Location of Construction:	Owner:	t Banlty Assoc.	one:	'ermit No: 99 0 0 6 4
Owner Address:	Lessee/Buyer's Name:	Phone: Bu	isinessName:	
Contractor Name:	Address:	Phone: 773-54	99	Permitissued: ISSUED
Past Use:	Proposed Use:	COST OF WORK:	PERMIT FEE: \$ 25,80	JAN 2 5 1999
Office	Same	FIRE DEPT. ☐ Appro ☐ Denied Signature:		Zone: CBL: 063-C-004
Proposed Project Description:		PEDESTRIAN ACTIV	ITIES DISTRICT (PA.)	Zoning Approval:
Brect Signage		Action: Appro Appro Denie	oved with Conditions:	□ Special Zone or Reviews: □ Shoreland □ Wetland □ Flood Zone □ Subdivision
Permit Taken By:	Date Applied For:	January 21, 1999	Date.	☐ Site Plan maj ☐minor ☐mm

Re: 233 Vaughan Street Sign Permit

BUILDING PERMIT REPORT
DATI	E: 25 January 1999 ADDRESS: 233 Vaugh ST. CBL \$63-C-\$0
	SON FOR PERMIT: TO Erect Signage,
BUIL	DINGOWNER: Vaughn ST, RealTy ASSOC.
	TRACTOR: Fast Signs
	IIT APPLICANT:
USE (GROUP SIGNATE BOCA 1996 CONSTRUCTION TYPE
	CONDITION(S) OF APPROVAL
This I	Permit is being issued with the understanding that the following conditions are met:
Appre	oved with the following conditions: 41, 431
v 	,
$\frac{\sqrt{1}}{2}$	This permit does not excuse the applicant from meeting applicable Sta

233 Vaughn St. Proposed Sign Location

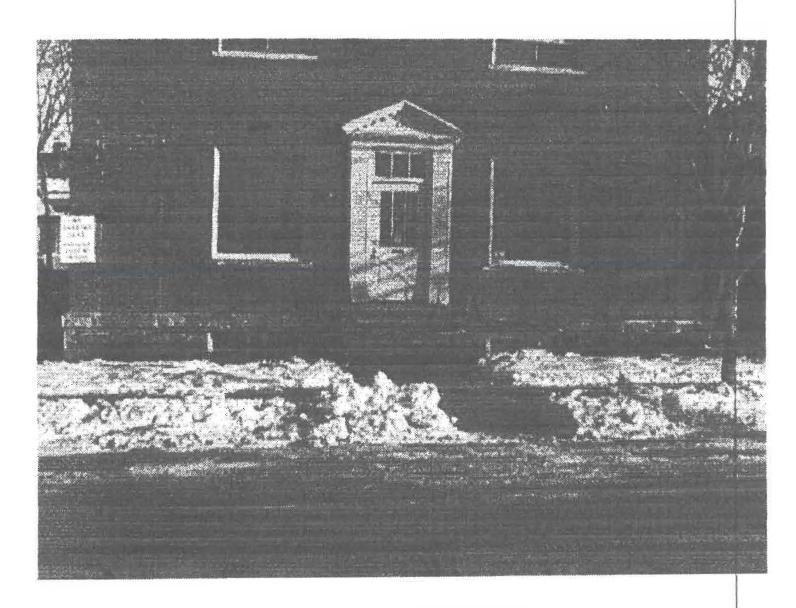
Sight Sq.ft 4.1 https:// Spothigh Setbock 5' must be on spothigh
